March 16, 2017

Re: FN 418312-2-52-01, 1st Street East
Dispute No. 1, Asphalt Base

ISSUE: Is the Contractor entitled to compensation for being forced to use Asphalt Base?

RECONSTRUCTION
STA. 39+28.00 TO STA. 86+82.30

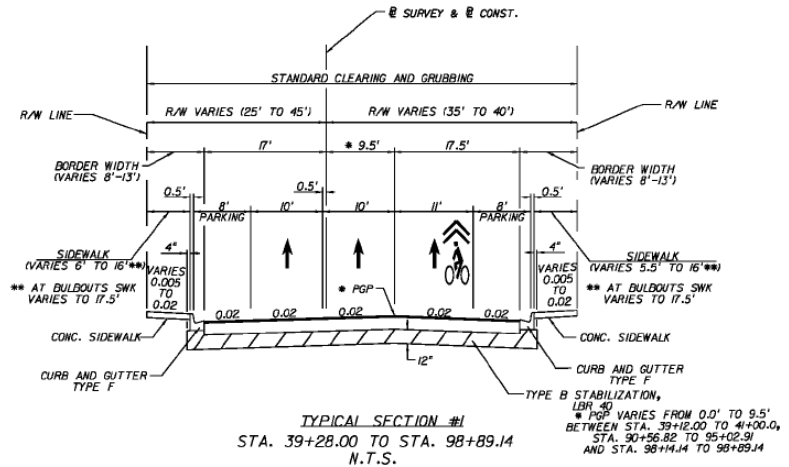
The area in question is from Sta. 39+28.00 to Sta. 86+82.30 where the base option indicates “Optional Base Group 9 (Type B-12.5).” The Department’s stated intent is that only asphalt base is to be used. The contractor believes that the word “only” should have been inserted after (Type B-12.5) to avoid any confusion. This statement is based on an examination of other construction plans in the same general vicinity as this project. Further, these other plans contained curb pad details for situations where asphalt base is utilized. This project did not. Since the word “only” was omitted, the prudent contractor is then forced to examine other parts of the contract documents in an attempt to ascertain the designer’s intent. JVA pointed out that plan sheet SQ-11 notes that the Department assumed a limerock base option for the purposes of establishing an excavation quantity.

1. There is sufficient confusion to lead the bidder to assume limerock base was acceptable. The plans do not give a clear direction as to the Department’s intent.

2. Although the typical section description includes “Optional Base Group 9 (Type B 12.5)” the typical section as shown could be interpreted to allow the use of the limerock base option. The base box in the typical is generic, there is no indication of the required asphalt curb pad under the curb and gutter. While there is no contractual requirement for the Department to depict the curb pad, this appears to be a practice (or) customary way of dealing with Type B 12.5 on an adjacent project; i.e. the typical was not sufficiently clear.

3. The Department’s stated intent was to require Type 12.5 base for the majority of the project; but, in the Summary of Quantities, the excavation pay item note assumes a limerock base option. While it could be argued that this note is academic and simply establishes an equal benchmark for all bidders, as to excavation quantity, the fact that limerock base was assumed by the Department further confuses the intent of the typical section.

The Board disagrees with this statement. The Department is relying entirely on the typical section description without due consideration for other plan details that if included would have clarified Department intent.

It is not a question of which statement is more compelling. The excavation calculation is in conflict with the note.

The Board finds that the Contractor is entitled to additional compensation if forced to use asphalt base.
